TMC SPECIFICATION NO. S-669

TITLE: GPT-40K 2-28MC MODIFICATION (10K DRIVER & 40K PA)

KIT-119

FIGURE 1- REAR VIEW 10K PA COMPARTMENT

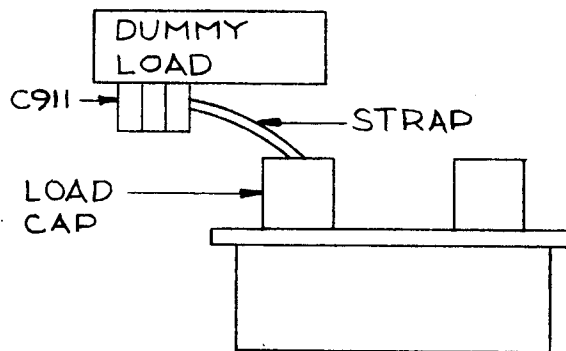
- A. KIT-119 is made up of three individual Kits; KIT-118, KIT-120, and KIT-131. Each Kit is self-contained and has its own installation procedure, which should be followed (except for some minor alterations as described below) although KIT-120 and KIT-131 should be done simultaneously while the 40K section is disassembled.
- B. When using KIT-118 on the 10K driver section of the GPT-40K the DC blocking capacitor, C911, is mounted in a new position. The strap connecting this capacitor to the variable load capacitor as indicated in KIT-118 installation procedure section V-15 is also repositioned as shown in Fig. 1 below.

OLD POSITION
10K TRANSMITTER

NEW POSITION
10K DRIVER
